PROJECT
Sutton Courtenay RRP

Energy from waste (EFW) incinerator infrastructure plus that for combined heat and power (CHP), incinerator bottom ash (IBA) processing plant with outside storage area, and air pollution control residue (APCR) treatment and disposal facilities, visitor and office accommodation and landscaping.
WASTE RECYCLING GROUP, APPLEFORD SIDINGS, APPLEFORD

Energy from Waste Incinerator at the Sutton Courtenay Resource Recovery Park.

ENERGY FROM WASTE INCINERATOR (EFW) INFRASTRUCTURE PLUS THAT FOR COMBINED HEAT AND POWER (CHP), INCINERATOR BOTTOM ASH (IBA) PROCESSING PLANT WITH OUTDOOR STORAGE AREA, AND AIR POLLUTION CONTROL RESIDUE (APCR) TREATMENT AND DISPOSAL FACILITIES, VISITOR AND OFFICE ACCOMMODATION AND LANDSCAPING; AT SUTTON COURTENAY RESOURCE PARK, CORRIDOR ROAD, SUTTON COURTENAY

TITLE
EW Building Elevations

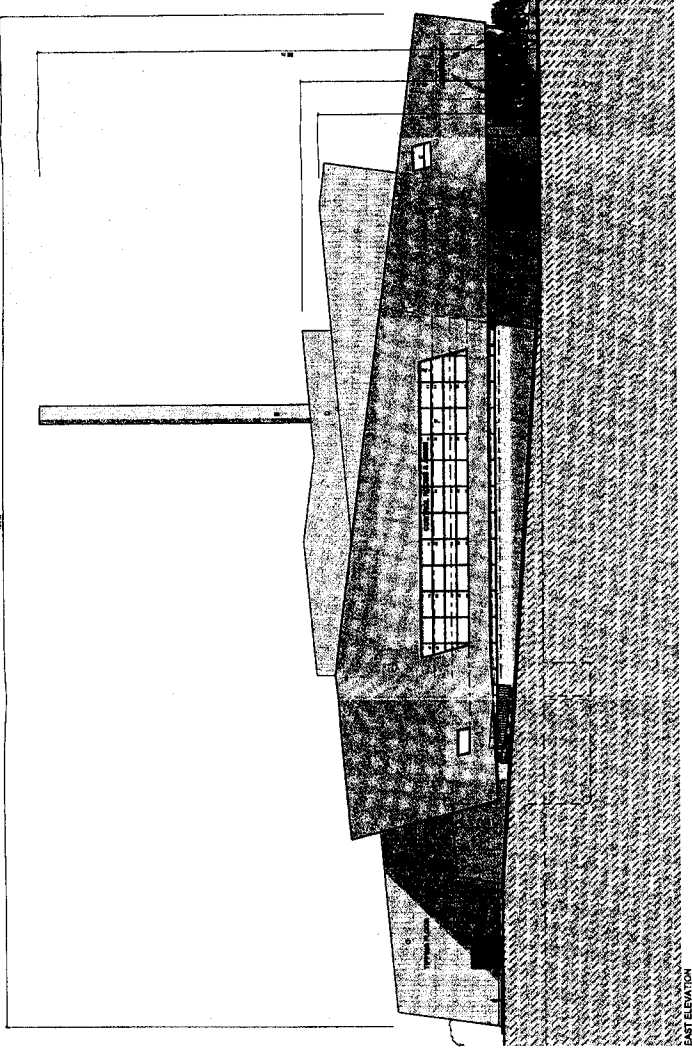
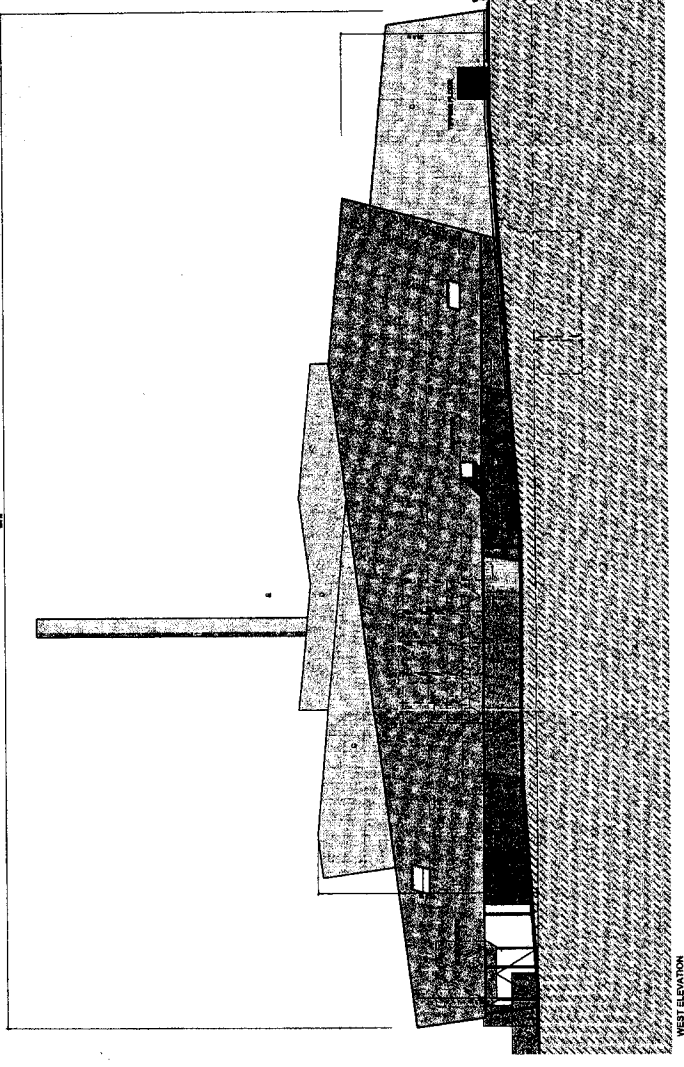
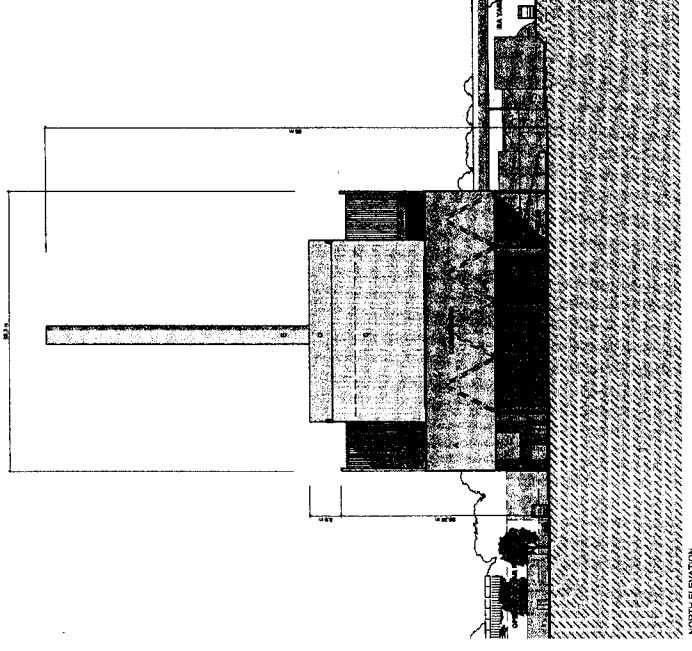
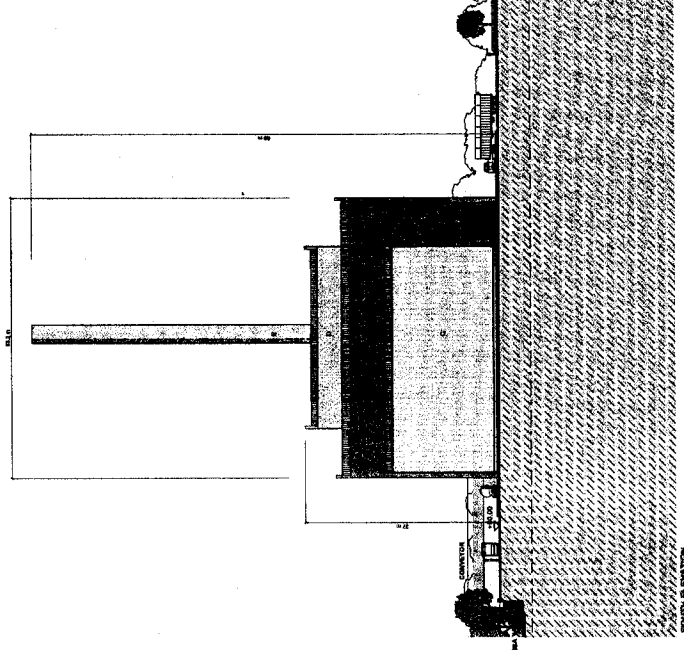
We have to suppose, I think, that the main building is no more massive than its function requires. If that be so the design decision to treat it as a cubist composition of rhomboidal forms creates interest. It may accentuate length and minimise the impression of height. Different colours on the different forms would add to the sculptural qualities which I perceived to be the designers’ aim.

In short if this facility has to go here I regard the design approach to the major building as being acceptable. The other buildings are suitably detailed as subsidiary features of the proposed complex.
